Please see **Attachment A, LM Selection sheet**. Note that

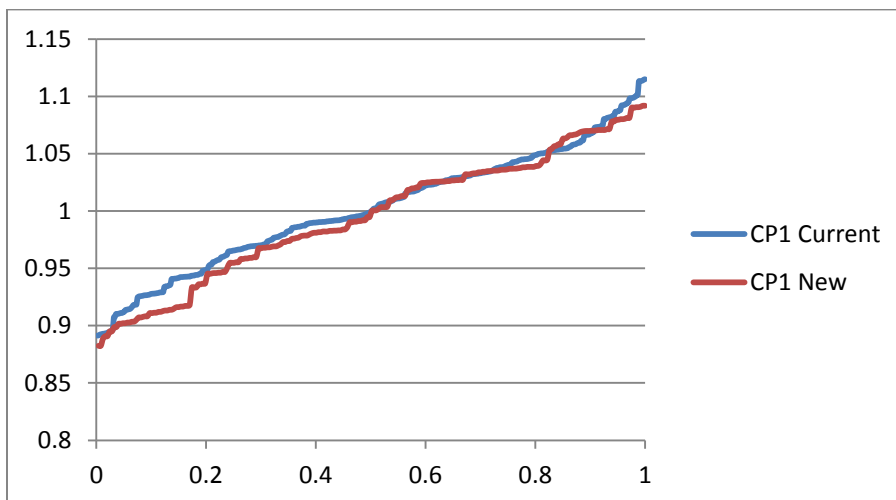
So is there a load model that

1. Has a reasonable standard deviation in peak week (unlike your #50714, which is an outlier in this regard); and
2. Has World peaking in a different week from PJM (peaking in same week greatly overstates risk, due to representing “world” as a single thing, ignoring hourly diversity, etc. etc.); and
3. Has the World pattern such that it allows realizing nearly all of the 3500 MW of potential CBOT (unlike 50703);
4. Is a reasonable fit to CP1, of course.

- The selected LM is highlighted in yellow
- There is no perfect correlation between Standard Deviation of the peak week and single area IRM or two-area IRM.
- The Load Model Selection methodology indicates that we should select a load model based on how well it fits the CP1 distribution from the Load Forecast via Approaches 1 and 2.
- We tend to favor Approach 2 since it does not rely on random number generation.

Comparison of CP1 – Entire Distribution

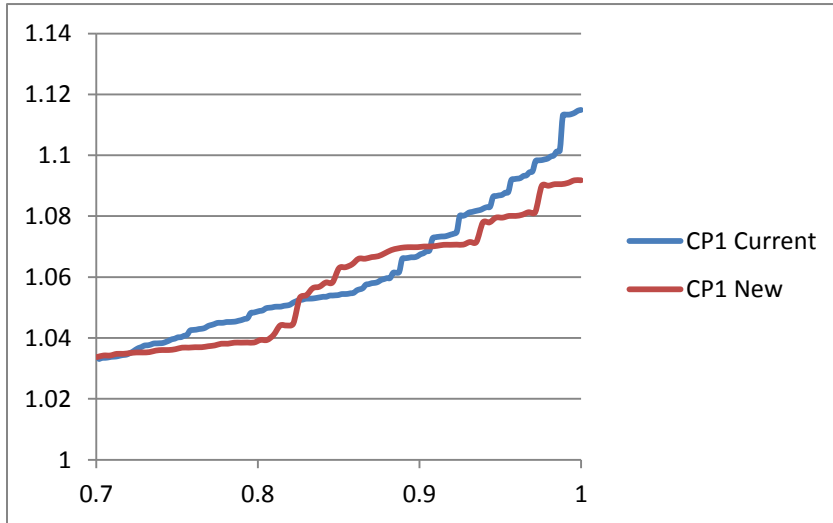
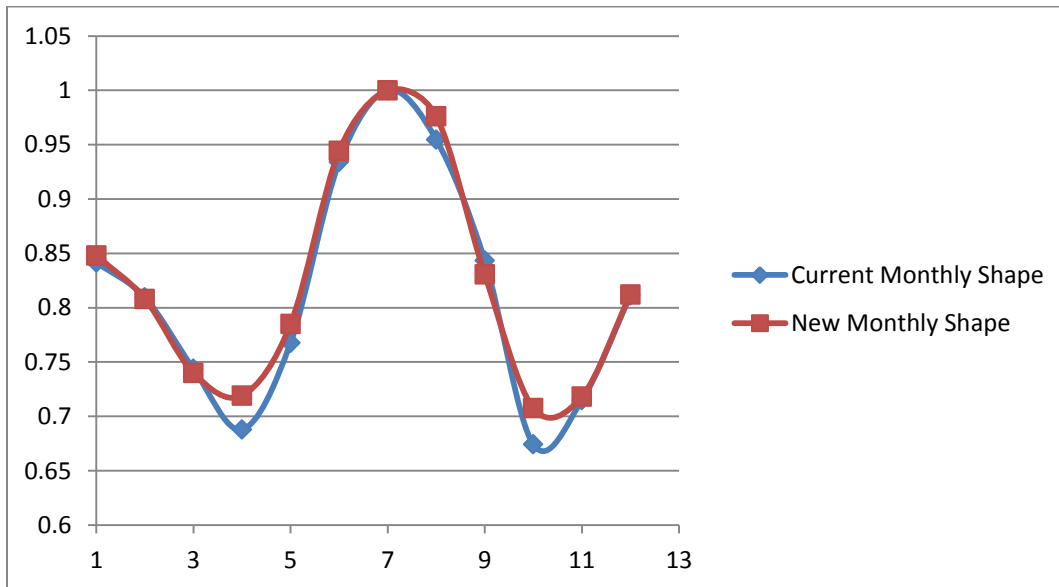
1. Also, are you comparing to CP1 from the old load forecasting model, or the revised methodology? The new methodology has revised weather splines and other changes that could affect the shape, and the fit of load models. If you had been comparing to the old CP1, can you provide a graphic that compares the old and new CP1 distributions, and then shows how the various short list candidate load models compare to the updated CP1.

The new forecast specification also changes the PJM monthly shape as follows,

We ran the load model selection process using the new forecast specification. The selected load model decreases the single area IRM. However, when we computed the two-area IRM with the selected load model, the result was 16.6%. The explanation for this result is as follows:

- The new CP1 curve is less conservative which decreases the single area IRM.
- The new monthly shape is more conservative (due to a higher August peak as seen in the figure above) which decreases the CBOT (since now PJM needs additional help in August, at the time when the World cannot provide it).

- The overall impact of using the new load forecast specification to calculate the IRM is an increase of 0.1 percentage points with respect to what we have shown to the RAAS and PC.
